Product / Process Change Notification (PCN)

PCN #: PCN_ConDSUB_20230627

Affected Series: WR-DSUB -618009231221

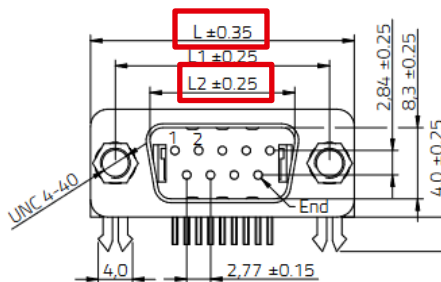
As a datasheet information amendment, Würth Elektronik will correct the L and L2 Values that have been reversed in the Article Properties section.

The L and L2 values have been reversed in the Article Properties section and will be corrected.

618009231221	L (mm)	L2(mm)
BEFORE	16.92	30.8
AFTER	30.8	16.92
